SR-2 – ADVISORY STAFF REPORT (06-05-2026)

ADDRESS: 100 TEMPLE

APPLICATION NUMBER: HDC2026-00172

The north side (top) and west end of 100 Temple. The multi-story bay windows, covered in painted plywood, are visible on both and are proposed to be removed, reframed, and boarded and then finished at a later time. (Staff photo, April 2026)

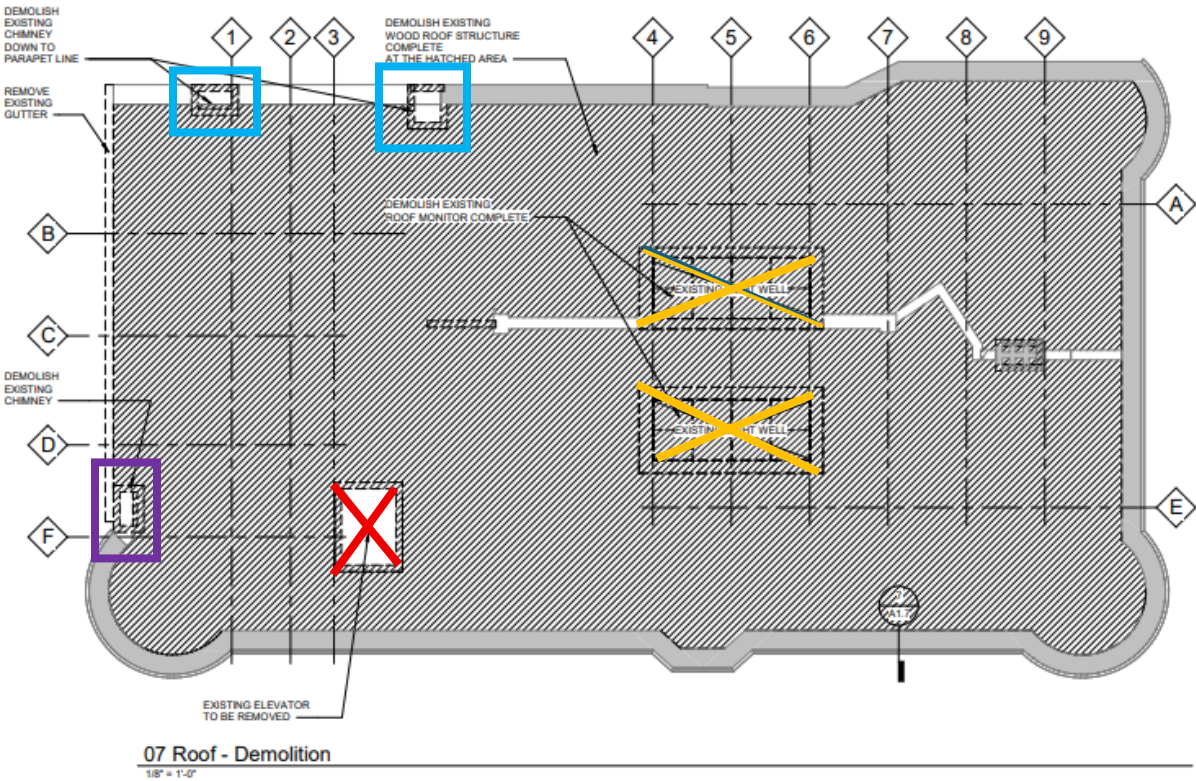
- **DOCUMENT, REMOVE, AND REBUILD BAY WINDOWS ON THE NORTH AND WEST SIDES OF THE BUILDING.** The north and west sides of the building are the secondary sides and are mainly utilitarian but both have multi-story stacked bay windows that are historic and character defining. These windows are proposed to be fully documented for rebuilding and then removed so that structural issues can be addressed. The application states that the windows will be removed and “Temporary painted plywood sheathing will be provided at the bay windows until a tenant has been identified for the building and a full renovation occurs, at which time the bays can be fit with windows, cladding, and trim to match the originals.” The applicant clarified in a conversation with staff June 3, 2026 that the new framing would be erected in the bay window shape, and this bay window structure would be roofed, sheathed, and made watertight and boarded, but the windows, siding, and trim would be added later at an undetermined date, as part of larger rehabilitation efforts.

- If the windows must be dismantled because of deterioration of the floor structure that supports the bay windows, it is staff’s opinion that the rebuilding of these character-defining features should happen immediately after the structural issues are addressed. It is staff’s opinion that removing a character-defining feature—especially a large, highly visible, significant feature—without a plan to replace it very soon after its removal could complicate the ultimate restoration of the feature, should the building be sold or the rehabilitation

1. If the bay windows on the north and west sides must be dismantled because of deterioration of the floor structure that supports the bay windows, these bay windows must be reconstructed as per the measured drawings and photodocumentation immediately after the building's structural issues are addressed.

1 07 ROOF PLAN
1/8" = 1'-0"

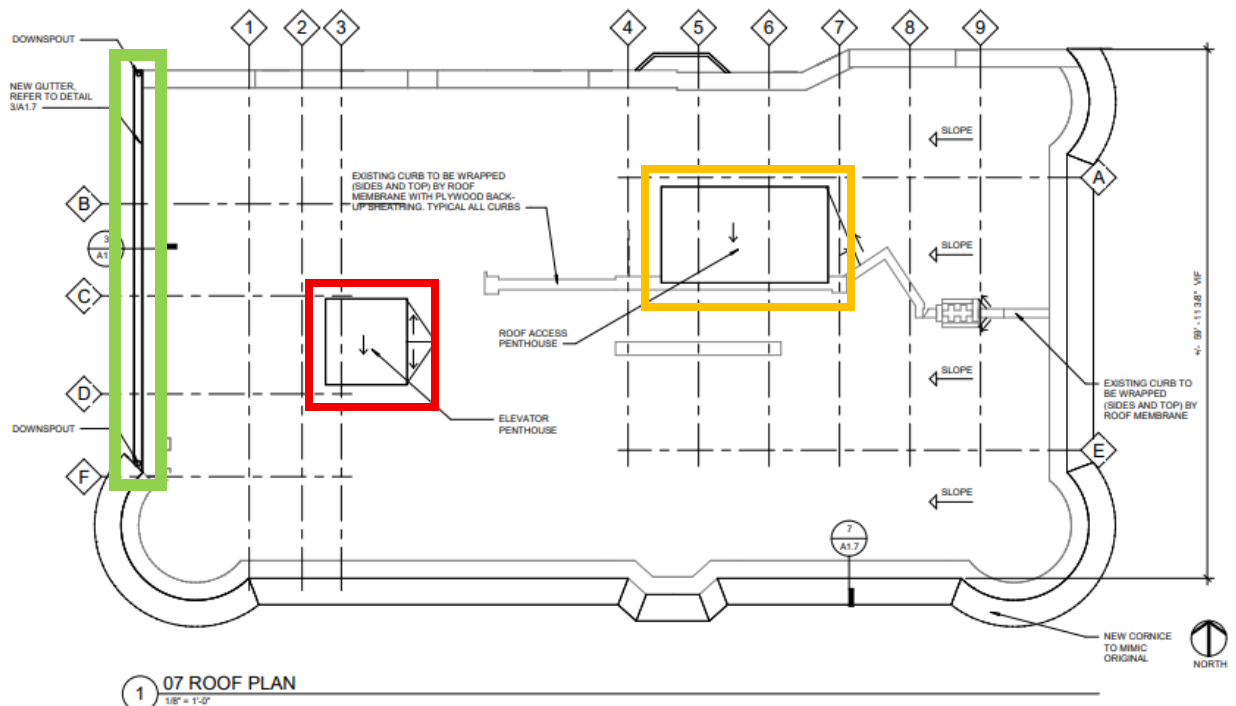
- **CONSTRUCT NEW ELEVATOR PENTHOUSE AND A NEW ROOF ACCESS PENTHOUSE.**
 - The existing elevator penthouse is quite close to the edge of the roof on the building’s south side. It is proposed to be removed, and the new proposed elevator penthouse would be set further back from the south side, more centered on the roof. The drawing included in the application materials showing the materials to be demolished on the north elevation (page 14 of the application materials PDF, sheet labeled AD3.0) shows “Top of the Penthouse” at 73’ 8”, but the existing elevator penthouse is shown to be slightly taller than that in the drawing. The applicant clarified by

phone June 3, 2026 that some of the building's roof is missing and access to the building is limited. Consequently, regarding the roof and penthouse heights, estimates were made from a lift several stories in the air and modeling for the drawings was based on those estimates. The applicant stated that the goal is that the new rooftop penthouses for roof access and the elevator will not be taller than the existing penthouse. The drawing on page 18 of the applicant's PDF, or sheet A3.1.1, shows the two new rooftop penthouses for the elevator and rooftop access as one masonry course plus coping taller than the 73' 8" estimate for the top of the existing penthouse. As drawn, staff would find the design of the two rooftop penthouses compatible with the building. Without accurate dimensions for the existing and the proposed penthouses, however, and without specified masonry materials for the penthouses, staff is unable to make a recommendation regarding the proposed penthouses.

Roof plan showing demolition plans, from applicant materials. Three chimneys are shown; two are to be reduced to the parapet line (outlined in blue) and one is to be demolished (outlined in purple). The existing elevator and penthouse is to be demolished (marked with a red X), as are the existing rooftop monitors and lightwells (marked with gold Xs). The entire wood roof structure is to be demolished and all the wood floors from floors 1 through 6 are to be demolished.

The new roof plan from applicant materials. The proposed elevator and elevator penthouse are outlined in red and the proposed stair shaft and rooftop access penthouse is outlined in gold. The new roof will be a membrane roof and the gutter and downspouts are proposed for replacement (shown in green).

4. As per the plans and elevations included in the application, the rooftop penthouses for the new proposed elevator and rooftop access are compatible with the historic building in concept. However, more detailed drawings of the existing penthouse and the proposed penthouses, as well as the specifications for the masonry materials to be used to construct the penthouses, must be submitted for Commission review before construction begins.
